SERVICE SLANTS

ISSUED BY WURLITZER SERVICE DEPT. NORTH TONAWANDA, N. Y.

THIS SLANT IS DESCRIPTIVE OF HOW THE NEW MODEL 3031 MULTI-WIRE WALL BOX MAY BE USED IN CONNECTION WITH THE OLD STYLE MODEL 130 ADAPTER.

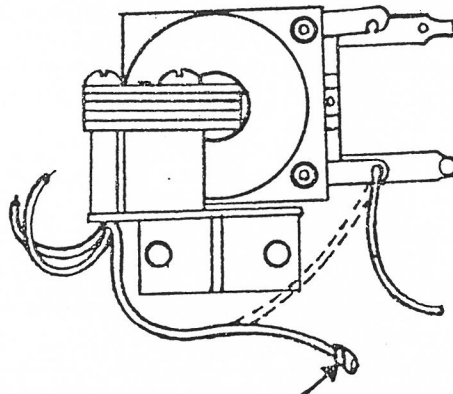
When connecting a Model 3031 Wall Box it will be found that the coin switch magnet remains energized after coin passes through coin switch.

Correct by removing Brown wire from coil of coin switch magnet. (tape end of wire) See sketch below.

Also place jumper wire from No. 25 to No. 28 of terminal board in wall box. See sketch below.

Install jumper wire.

Unsolder wire and tape end.

Cable connections are made from terminals No. 1 through No. 25 of terminal board on Model 130 Adapter to No. 1 through No. 25 respectively on board in wall box and Terminal No. 27 to No. 27. Do Not make cable connections on No. 26 or No. 28.
